UNITED STATES  
DEPARTMENT OF THE INTERIOR  
BUREAU OF LAND MANAGEMENTFORM APPROVED  
OMB NO. 1004-0137  
Expires: January 31, 2018**SUNDRY NOTICES AND REPORTS ON WELLS**  
*Do not use this form for proposals to drill or to re-enter an abandoned well. Use form 3160-3 (APD) for such proposals.*Lease Serial No.  
NMLC034711

BAYLUS CADE FED 10

30-025-33887-00-S1

OXY USA Inc. - Proposed  
Baylus Cade Federal #10  
API No. 30-025-33887

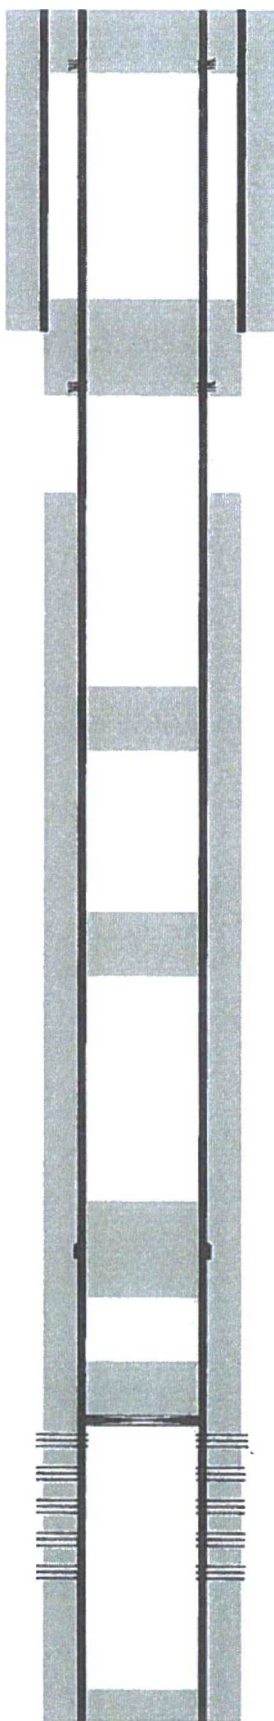
**\*\* BLM REVISED \*\* BLM REVISED \*\* BLM REVISED \*\* BLM REVISED \*\* BLM REVISED \*\*****FOR RECORD ONLY**  
MW/OCD 01/31/2018

30sx @ 2525-2325' WOC-Tag
